ENGINEERING EVALUATION OF THE WNP-2
SACRIFICIAL SHIELD WALL

SUPPLEMENT NO. 2

Attachment to letter G02-81-556,
Supply System (RG Matlock) to
NRC (RH Engelken), dated
December 29, 1981

FIGURE 1 LINEAR INDICATION IN RING 3 AT 135 -150°AZ

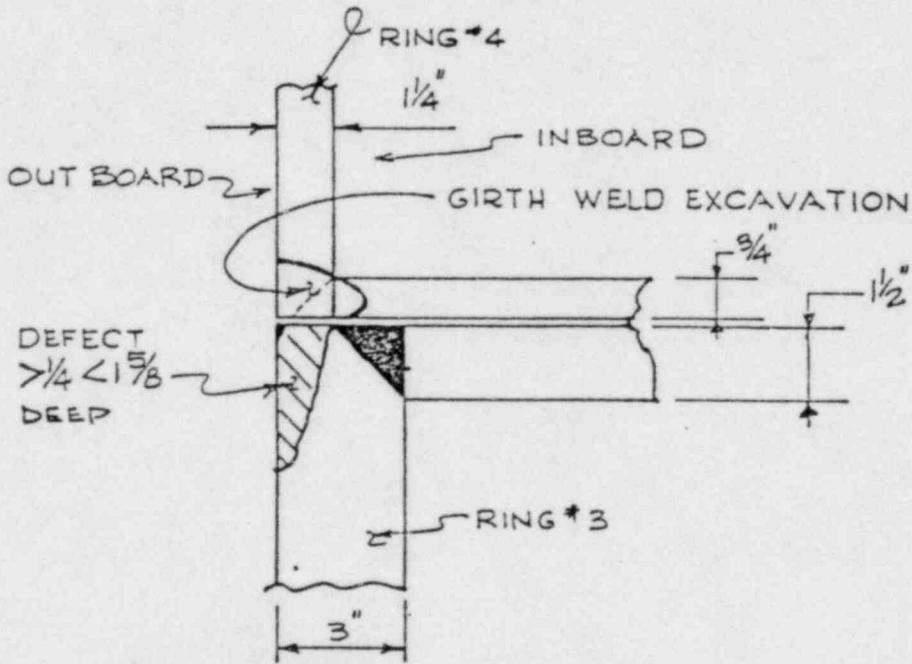
a. Linear indications in ring beam #3 between 135 and 150°Az (NCR 6648):

The location of this defect was reported two feet from the 150°Az at the approximate location of an electroslag weld. The area was etched, but the results were not conclusive.

Figure 1 provides an estimate of the size and location of the defect.

Leckenby had experienced problems with lack of fusion in electroslag welds and it is concluded that this defect was of the same type.

FIGURE 2 LINEAR INDICATIONS IN RING 3 AT 90-105°AZ

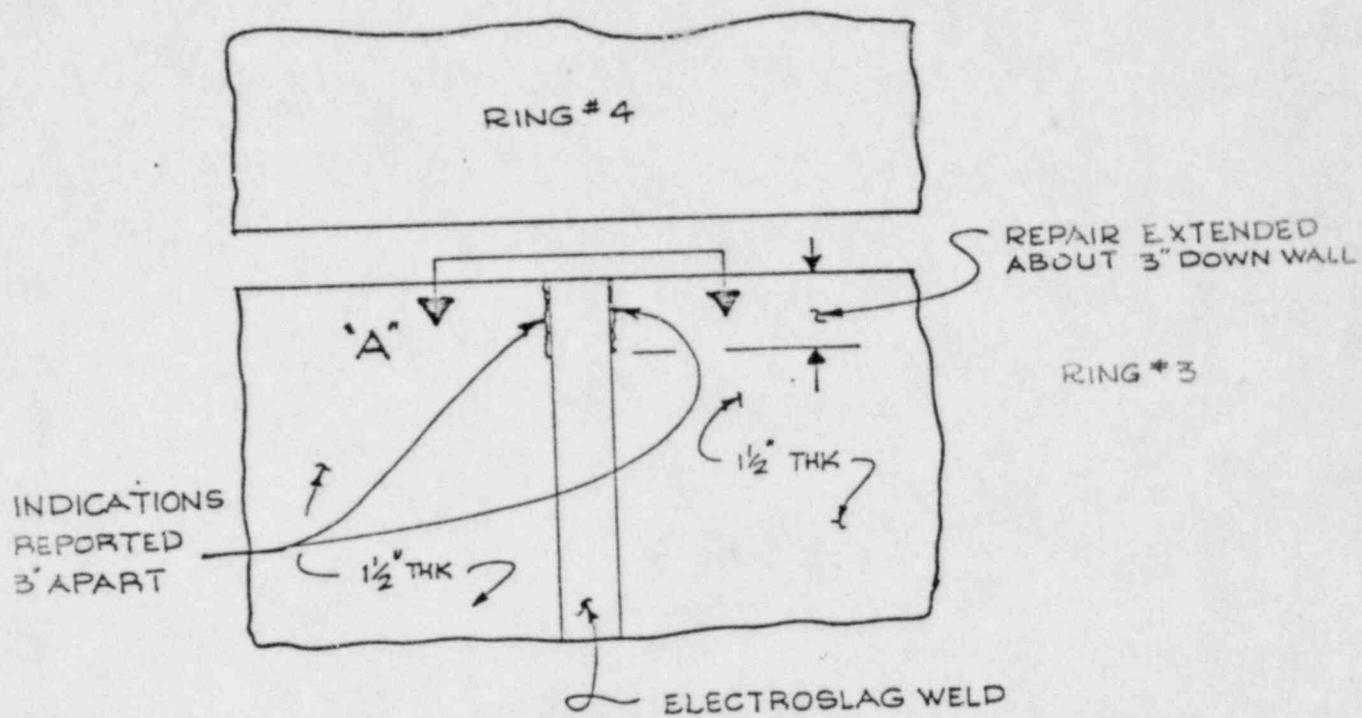
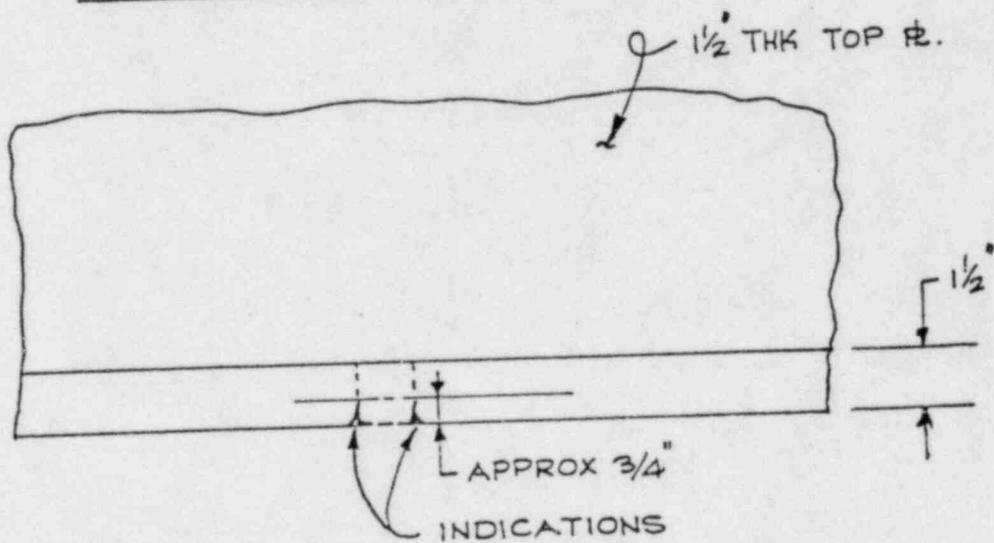
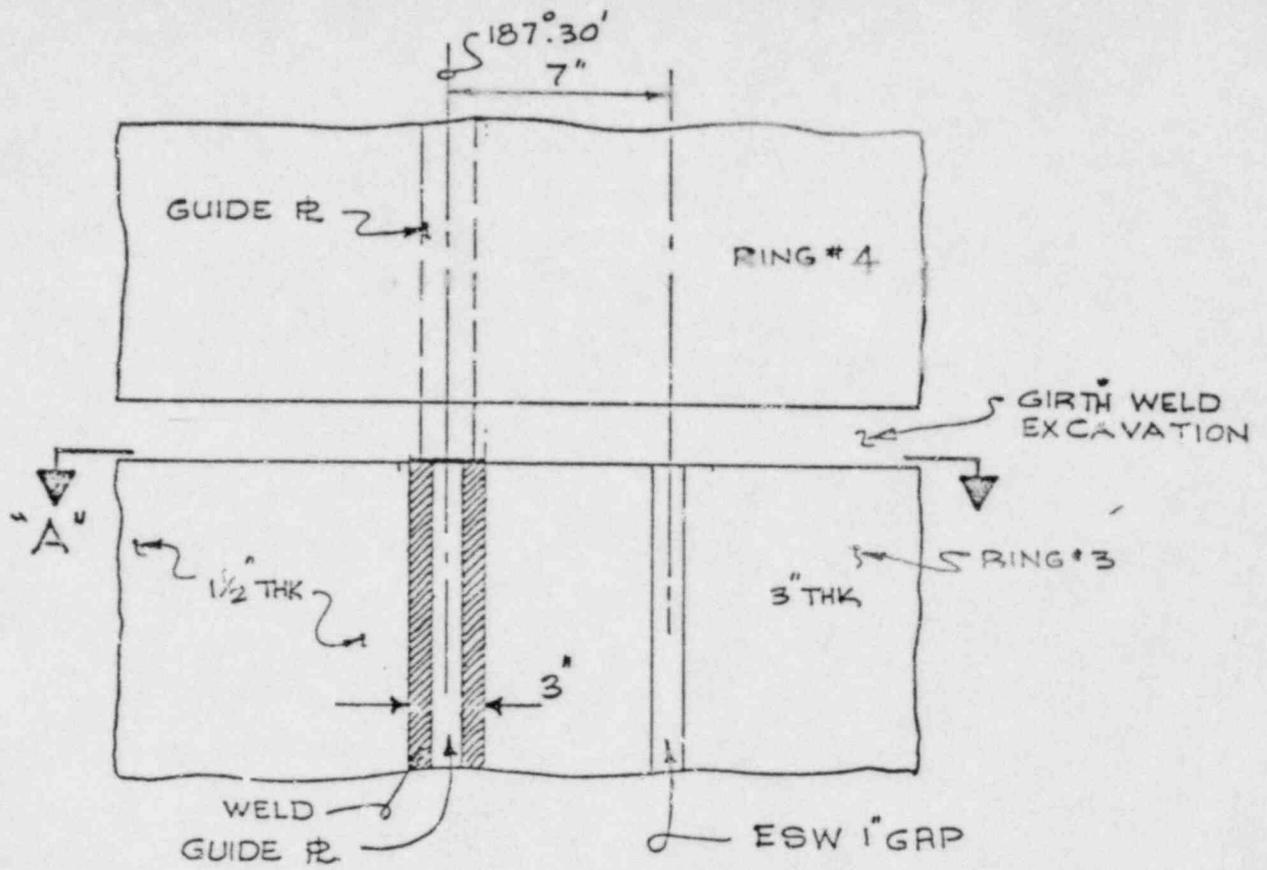
- b. Linear indications in ring beam #3, 90-105°Az (NCR's 6649 and 6652):

These indications were reported 2'3" from Az 105° in ring beam #3. The first indication was reported on NCR 6649 and the second on NCR 6652. The indications were about 3" apart.

The electroslag weld (ESW) at this location joins the front flange plates of ring beam #3 (Figure 2). The indications were probably at both edges of the ESW; the depth was approximately 3/4"; and the total length of repair down the face of the wall was about 3" (Figure 2).

It is probable that these indications were of the same type as discussed above.

FIGURE 3 GUIDE PLATE WELDS AT AZ 187°-30' (SIMILAR AT 67° AND 300-315°)

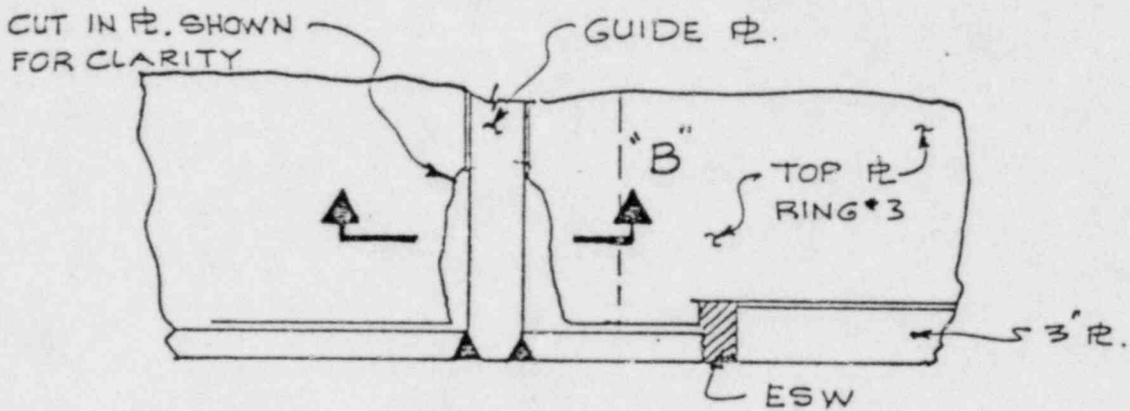
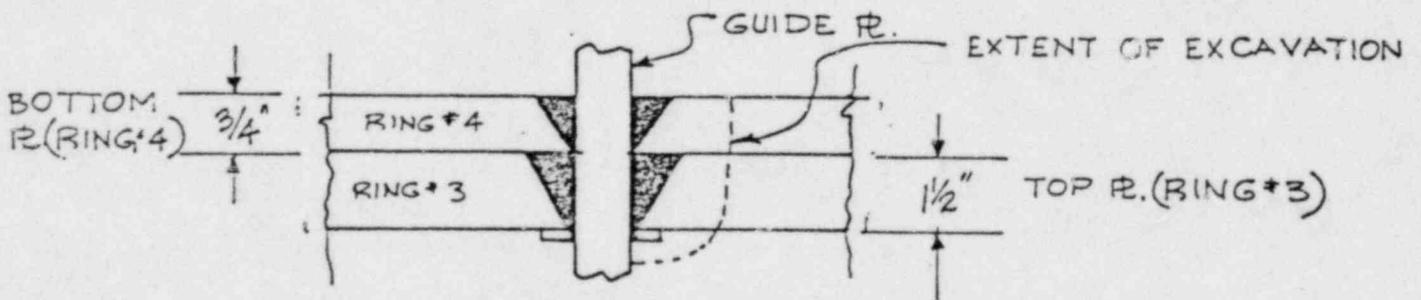
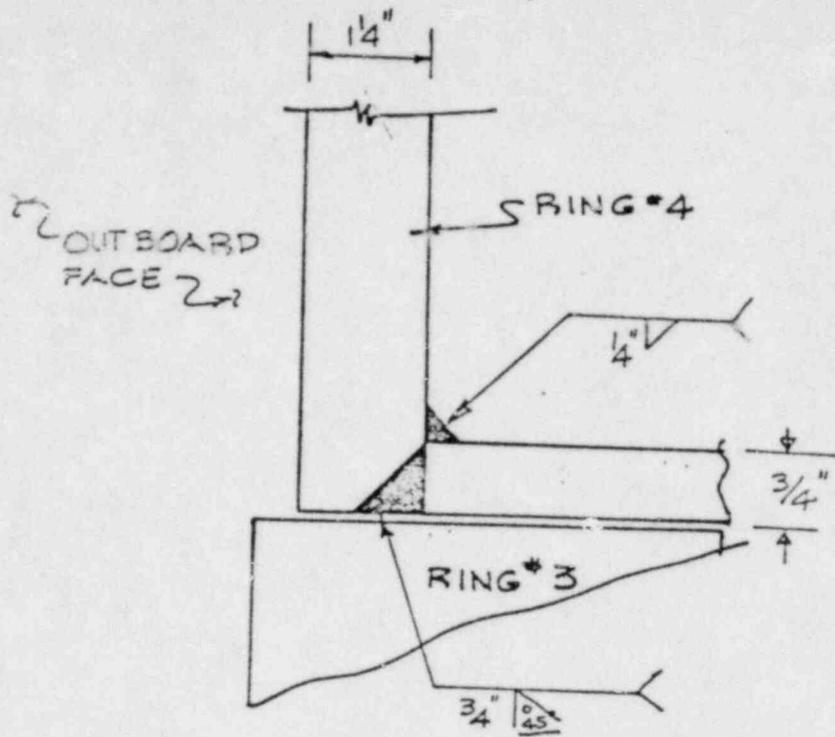
Linear indications and inclusions were found during the girth weld excavation of the guide plate welds (Figure 3). These indications occurred at three locations: 67°, 187°, and 307°. Guide plates were installed during the SSW fabrication only at these locations and the indications were in the welds joining the guide plates to the ring beams.

Extensive excavation was required to repair these indications primarily because of the requirement for an MT examination of the excavation and the need to go beyond the end of an MT indication. The indications were slag porosity and linear indications (i.e. slag stringers and lack of fusion).

- a. Rounded and linear indications at 67°Az (NCR 5640): the structure at this location is as shown in Figure 3. The indications were in the guide plate to ring beam welds and excavation through to the concrete was required. There was some concern as to the existence of the design fillet welds, therefore, the excavation was extended to confirm their existence. The problem with indications at this location was very similar to that encountered at 187°-30'.
- b. Indications at Azimuth 187°-30' (NCR's 6685, 6702, 6703, 6647):

The first indication (1/2" long X 1/16" wide X 1/16" deep) at this location was reported on NCR 6647. This defect was 17" clockwise from 180°Az and running normal to the face of the wall, i.e., in the excavation area and radial with respect to the SSW. An ESW is centered 15-1/2 inches from 180°Az in the front flange of ring #3 (Figure 3), so again this indication may have been at the edge of the ESW.

NCR 6685 shows that grinding in the area of the indication discussed above exposed linear indications and slag inclusions which extended back into the wall along the top of the ring beam. The indications at 187⁰-30' have resulted in the complete excavation of the bottom plate of ring 4 and the top plate of ring 3 through to the concrete and extending back about 18" to the inside web plates of the beams. A guide plate at this location is set through the bottom plate of ring 4 and the top plate of ring 3 (Figure 3). The indications were in the welds attaching the guide plate to the ring plates (Section BB of Figure 3). During the extensive excavation of the welds to the right of the guide plate, Figure 3 Sections AA and BB, lack of fusion was found just above the backing bar of the lower weld (NCR 6702). NCR 6703 documents a 1" long linear indication also located to the right of the guide plate. NCR 6702 also indicated that grinding occurred to the left of the guide plate. An indication was cleared from this area after grinding into the top corner of ring beam #3 through to concrete. NCR 6647 suggests that the indication was in the guide plate to ring #3 flange weld, not the electroslag weld.

In summary, most of the defects at 187⁰-30' were associated with the guide plate welds and consisted of slag and linear indications (about 1" long) throughout the welds. The requirement to grind 2" beyond the end of each indication lead quickly to major repairs for a few scattered defects.

c. Porosity slag and linear indications at Az 300-315⁰:

Again, there is a guide plate at this location with a geometry similar to that shown in Figure 3. Defects (slag, porosity and linear indications) were observed in the guide plate to ring beam welds. Linear indications were observed within the girth weld excavation, oriented in a circumferential direction. It is thought that the linear indications may have been areas where the excavation reached back to the root of the ring and web/flange weld.

The repair was deferred by isolating the SSW girth weld from the unexcavated region by use of backing material. Base material was built up to the SSW girth weld joint configuration using the SMAW process. A final magnetic particle examination was performed for acceptance.

Completion of the defect removal was performed by removing the ring 4 skin plate and concrete above the isolated area (PED 215-CS-A347) and excavating from above the ring 4 bottom ring beam web. When the inclusions have been repaired, material removed for access through ring 4 will be replaced. Inspections will be performed as required by AWS D1.1.

FIGURE 4 LACK OF PENETRATION AT AZ 90-105, 0-15, AND 180-195°

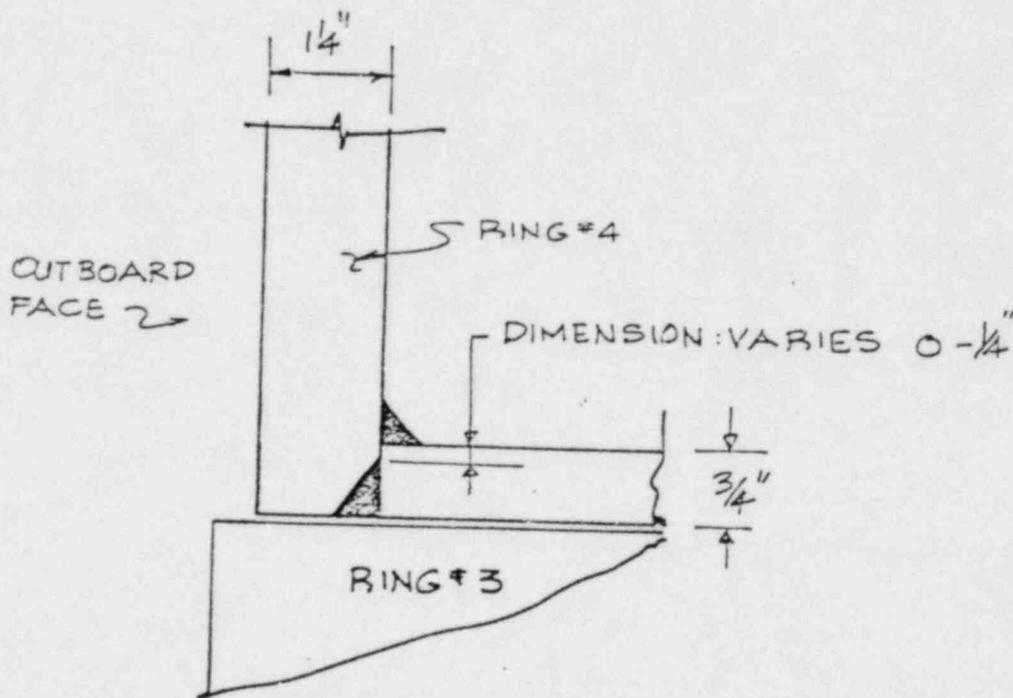
During preparation of the weld joint for the SSW girth weld, it was discovered that the ring 4 bottom beam flange to web weld was partial penetration, not full penetration as required by design. NCR 6643 was issued against this deficiency.

Design of the ring beam as shown on Burns and Roe drawing S782 requires the use of a 3/4" single bevel groove weld to join the 1 1/4" flange to the web of the ring 4 bottom beam. This joint is reflected on fabrication drawing W66, Section A-A, with an additional 1/4" fillet weld inside the beam as a nonstructural, fabrication convenience weld.

Partial penetration in the flange-to-web plate weld, ring 4 (Figure 4) was observed at three locations (90-105°, 0-15°, 180-195°). The MT indication resulted from lack of penetration at the root of the weld. Excavation of the girth weld revealed lack of fusion defects at the root of the weld joining the front flange plate of ring 4 to the web plate (Figure 4). The extent of the lack of penetration was estimated to be from 0"-1/4", based on the relationship between the profile of the excavation and the thickness of the web plate.

Linear indications in the girth weld excavation area were also noted at one location (300-315° Az). These defects may have resulted from the interface/lack of fusion observed elsewhere at the weld between the flange and web plate of ring 4, as discussed above.

In order to meet the design requirement for a full penetration weld, PED 215-W-A079 was issued to remove material from the ring beam flange to provide full exposure of the edge of the ring beam web. As a base metal repair, the contractor was directed to replace the removed material using the shielded metal arc welding process, restoring the geometry to that required for the SSW girth weld. Upon completion of the repair, the area was inspected by magnetic particle. The balance of the full penetration weld was then completed using the flux cored arc welding process.
